Rev D This document supersedes previous revisions.
Dec 09, 2014 Added road numbers.

UREA DOSING SYSTEM UPDATE Prevost vehicles

DESCRIPTION

Figure 7

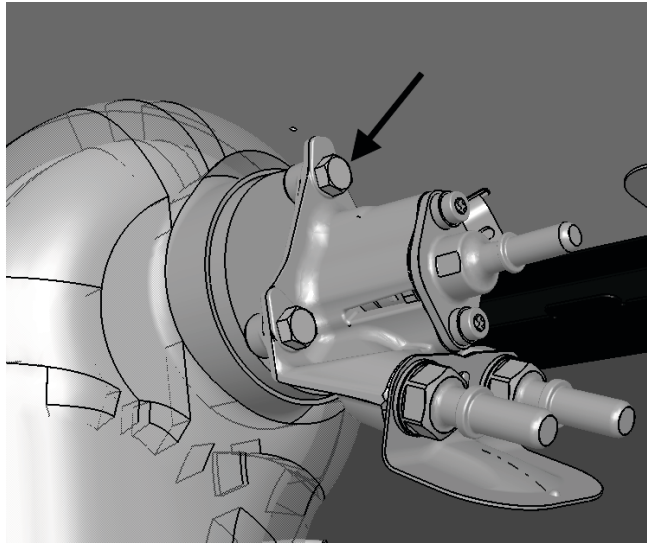
13. Remove the three bolts on the urea dosing valve.

14. Install new Urea Dosing valve **046557** supplied with kit.

15. Tighten bolts to 7.5 lbf-ft

Figure 12

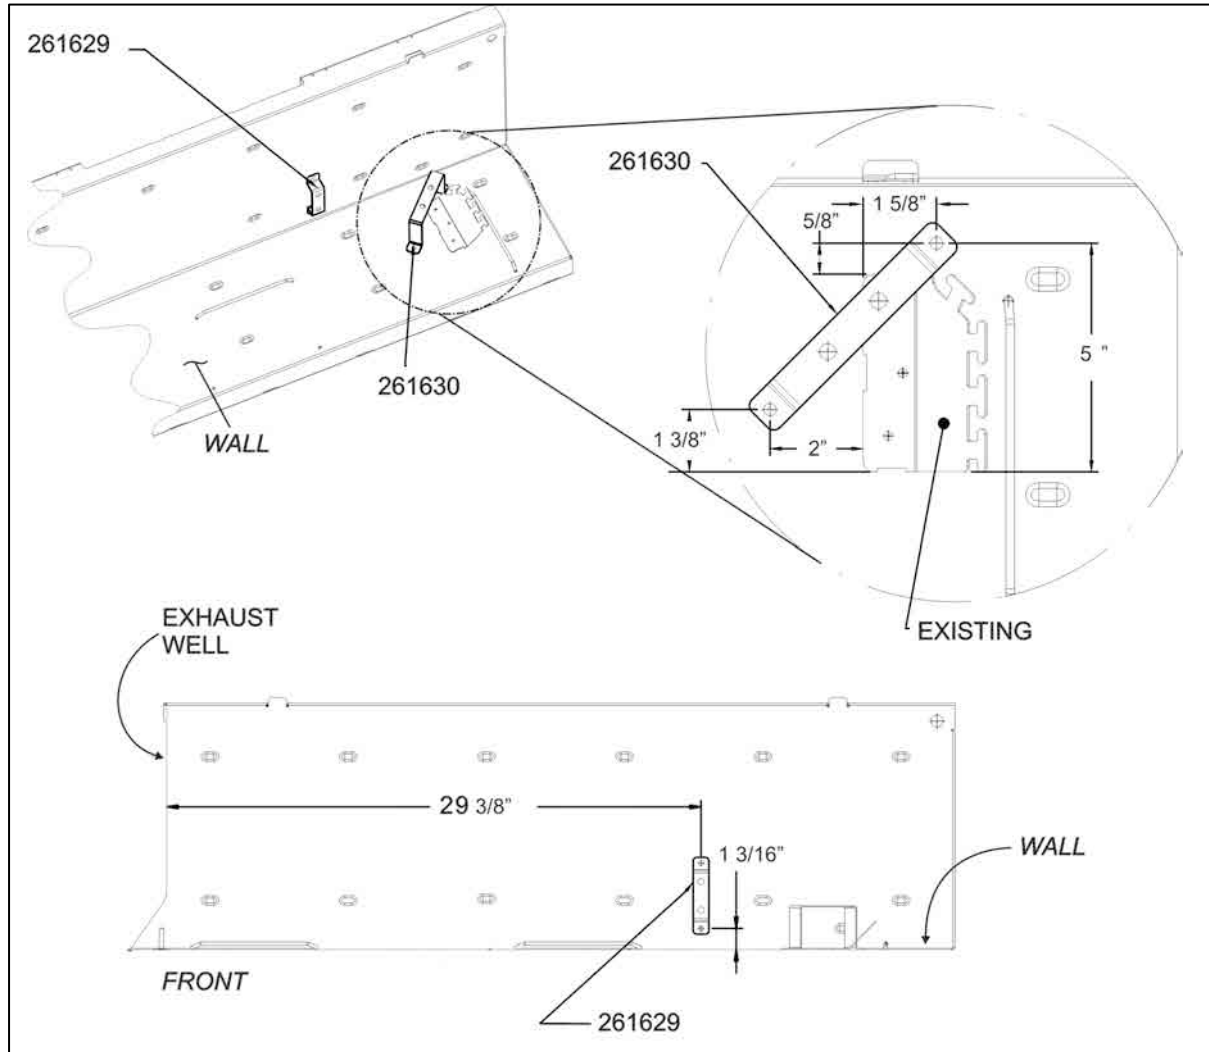
19. Mark drilling pattern for **261629** and **261630**, using brackets for hole pattern.
20. For **261629**, as a reference for measures, use wall and exhaust well edge (above exhaust bellows section) (Fig 12)
21. For **261630**, use existing hose management bracket as a reference.
22. Use a short neck, right angle drill fitted with a 7/32" stubby length (short) drill to make holes. (Fig. 11)

Figure 13

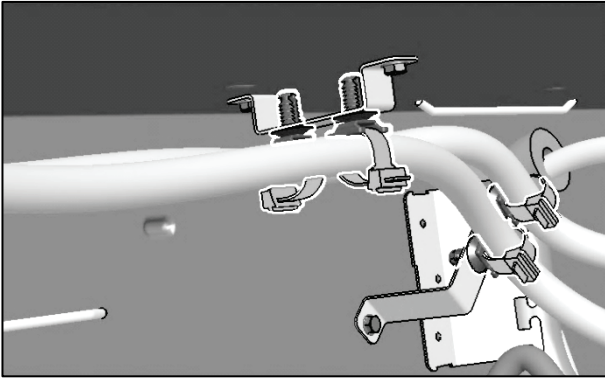
23. Assemble bracket **261630** and **261629** with **502848** thread cutting screws. Use a 3/8 socket.

24. Assemble coolant hoses with X-mas tree base cable ties (fig. 13). *Do not tighten cable ties.*

Figure 14

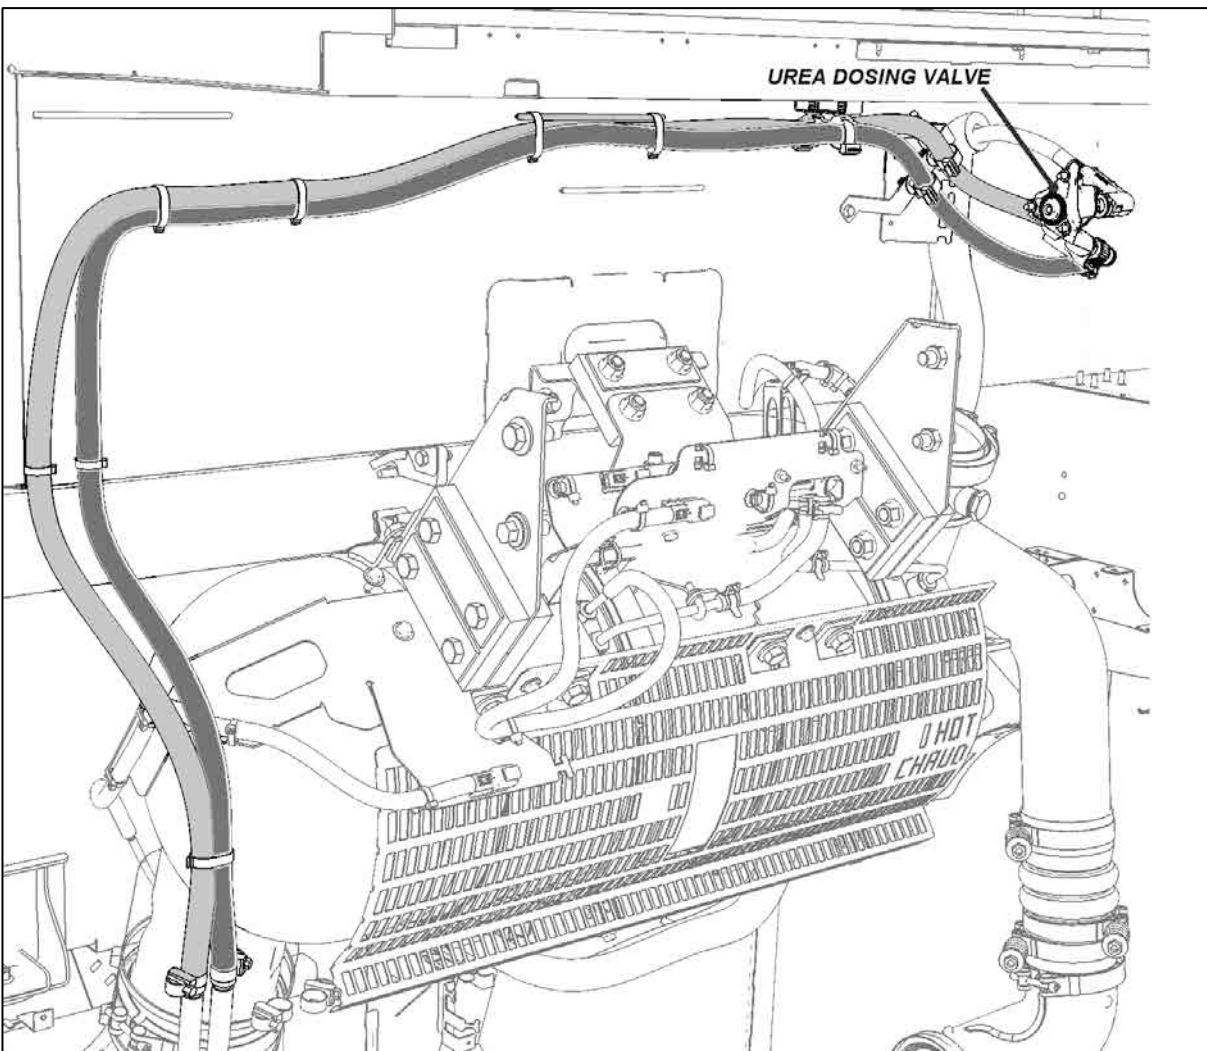
25. Route hoses according to figure 14. *Do not tighten cable ties to allow adjustments.*

Figure 15

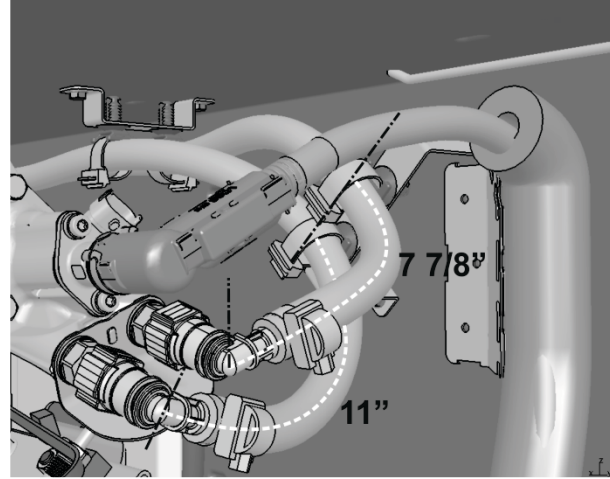
26. Adjust the length of the hoses to dimensions in fig 15.

27. Tighten all cable ties
